ADDENDUM TO THE CONTRACT

Gastineau Elementary School Renovation

Contract No. E11-137

ADDENDUM NO.: ELEVEN

SHEET #
M8.4

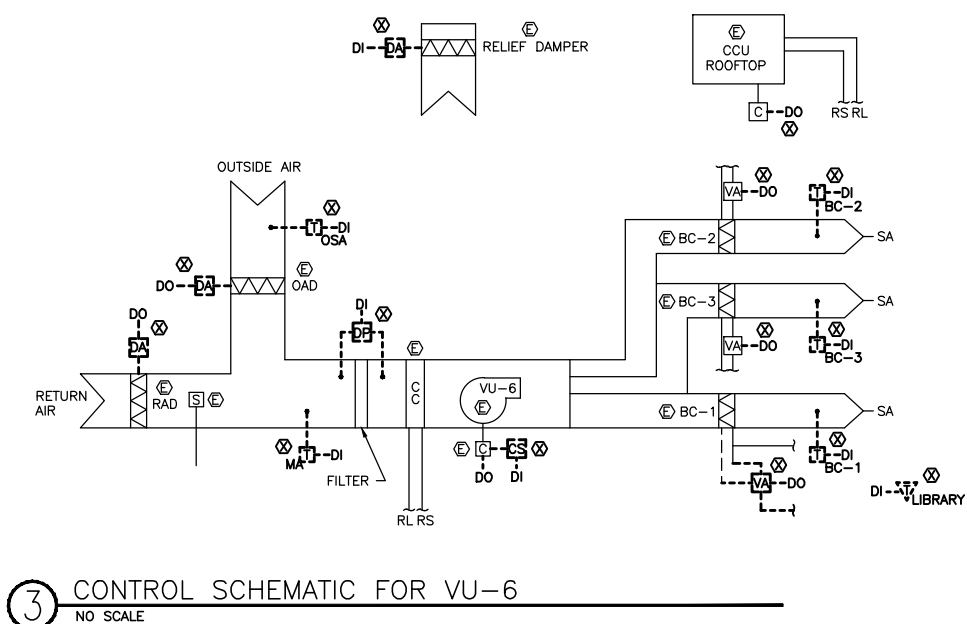
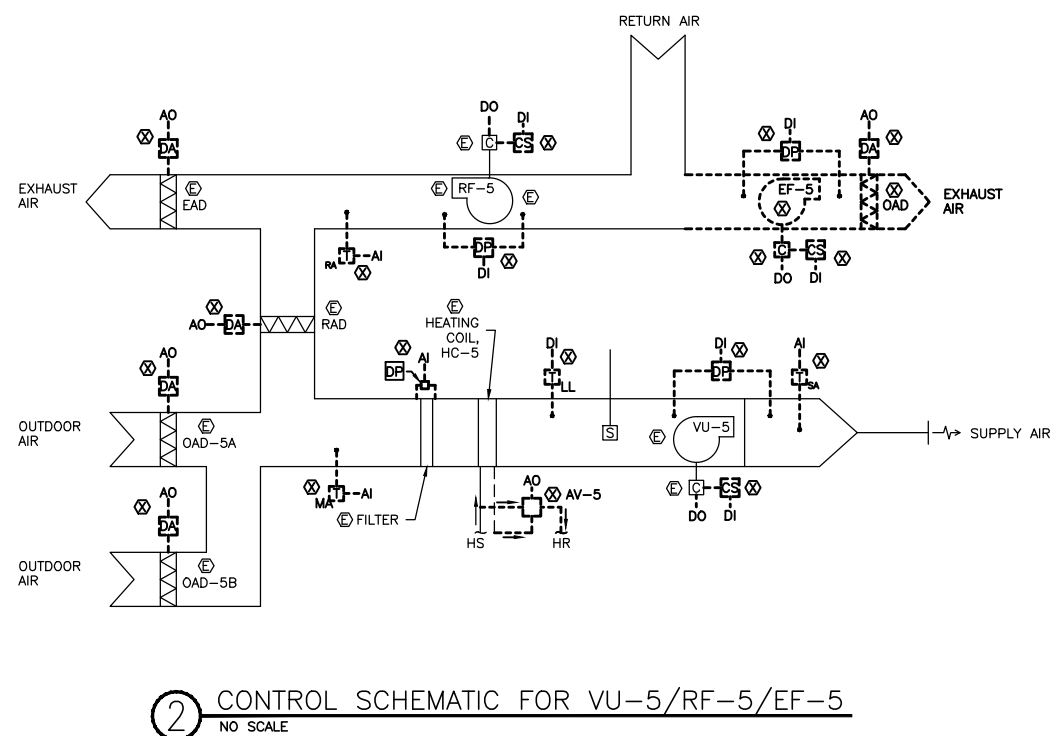
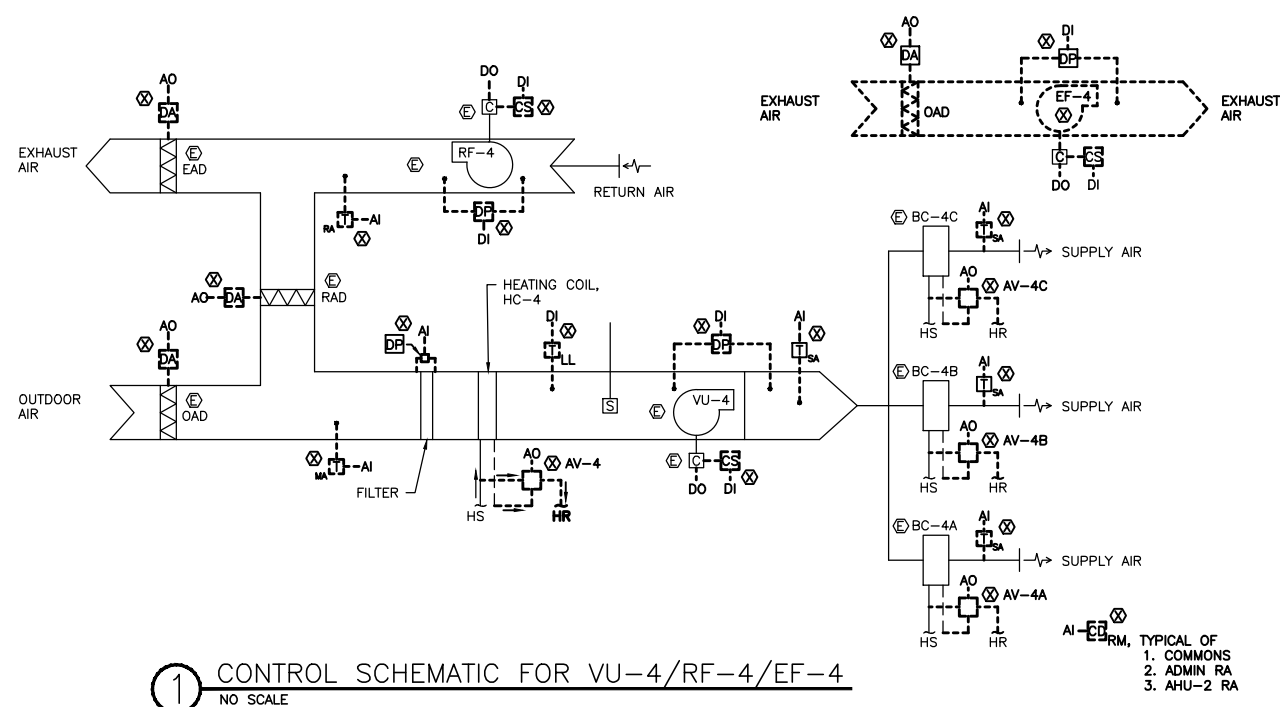
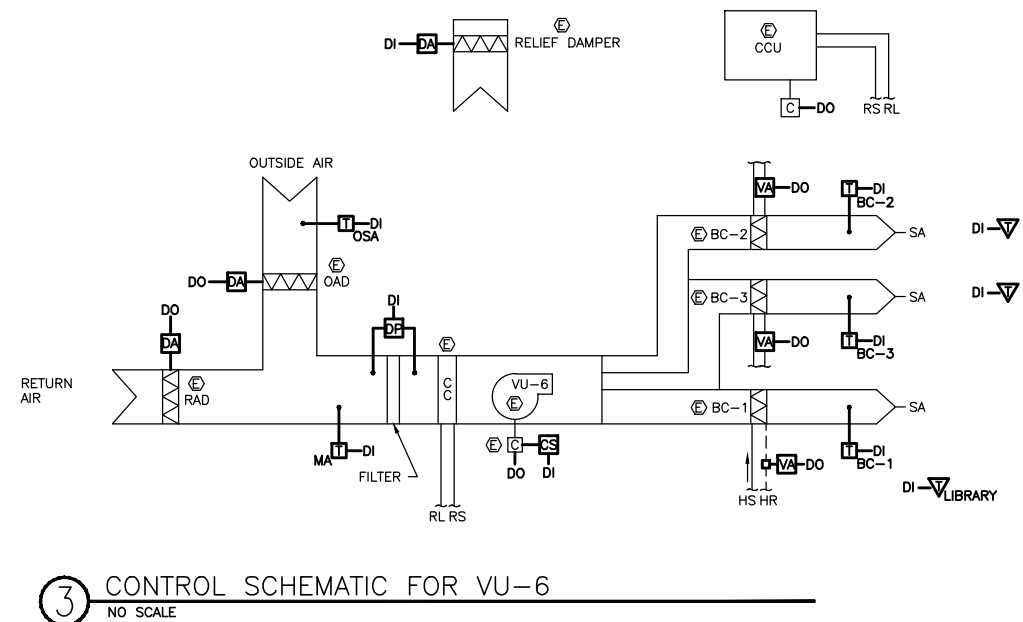
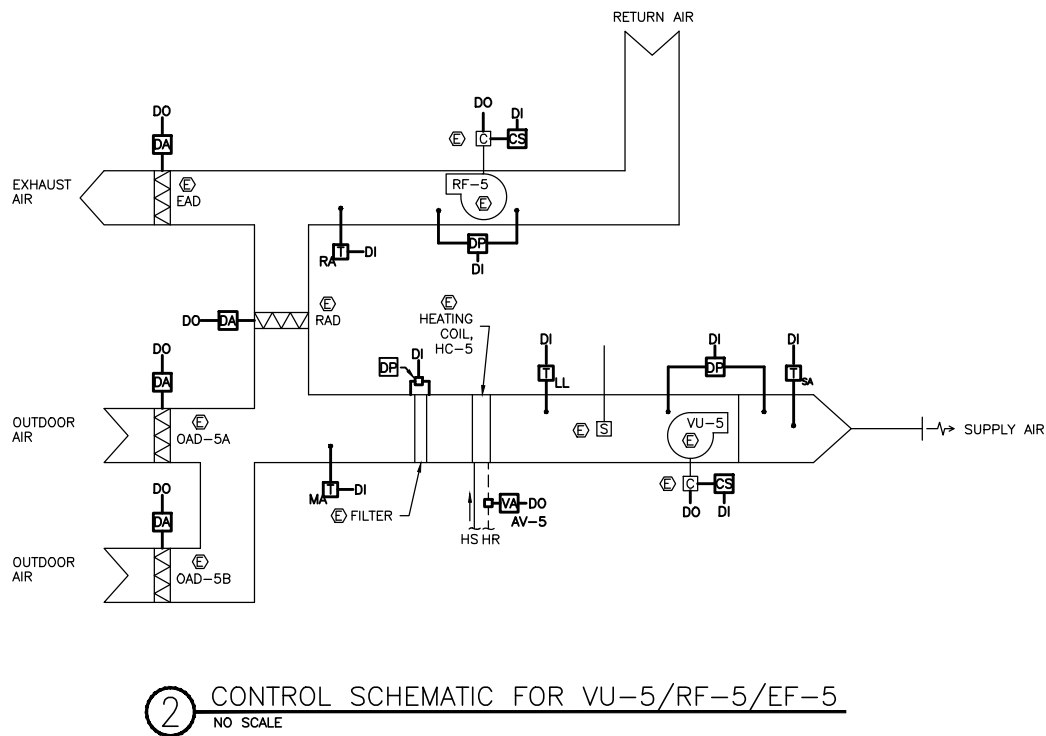
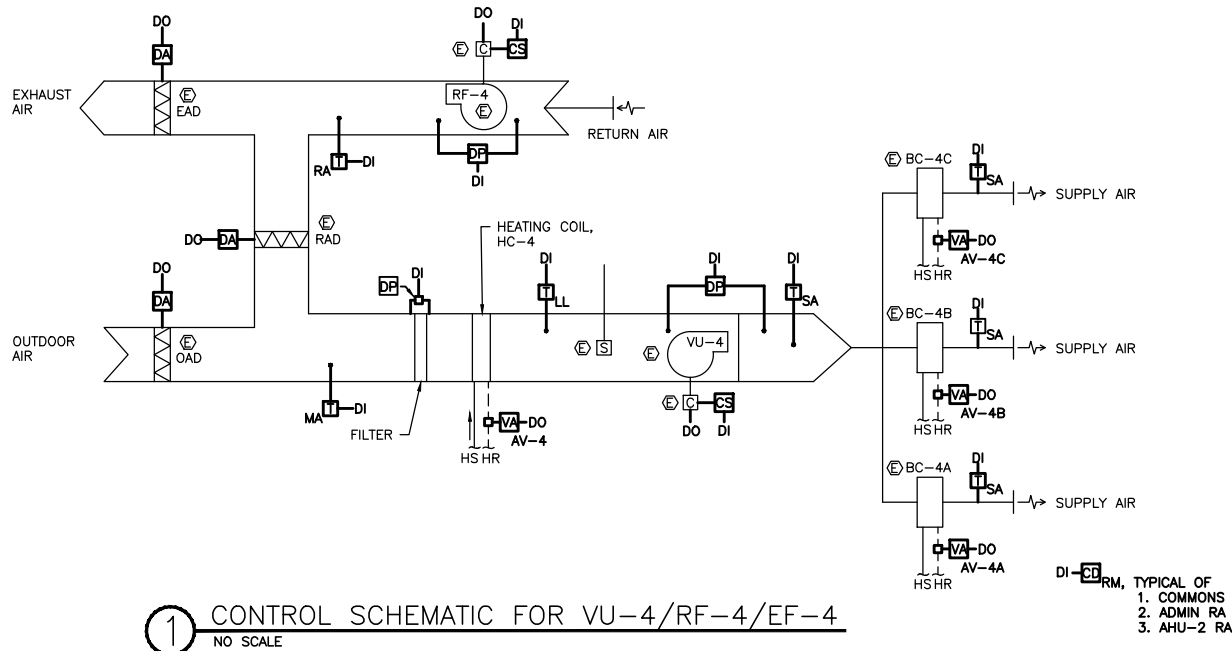
Item No. 26 DRAWING TITLED M8.4- EXISTING SYSTEMS CONTROLS

1. **Add** entire sheet. This plans shows the new work associated with controls points for existing fan systems VU-4, VU-5, and VU-6.

- SCOPE OF WORK: INSTALL BACNET COMPATIBLE GCM, CONTROL COMPONENTS, AND CONTROL PANELS. INSTALL DDC COMPONENTS ON EXISTING FAN UNIT TO REMAIN. COMPONENTS CONSIST OF DAMPER AND VALVE ACTUATORS, ALL SENSORS, THERMOSTATS, AND RELATED APPURTENANCES. INTENT IS TO REPLACE ALL CONTROLS ON EXISTING FAN SYSTEMS WITH BACNET COMPATIBLE CONTROLS.
- ROOM LOCATIONS FOR INSTALLATION ON NEW CONTROL PANELS AND GCM'S ARE AS FOLLOWS: BOILER ROOM 152, FAN 201, FAN ROOM 203, FAN ROOM 202, & JANITOR 150 NEAR LOCATION OF CONTROL COMPUTER.
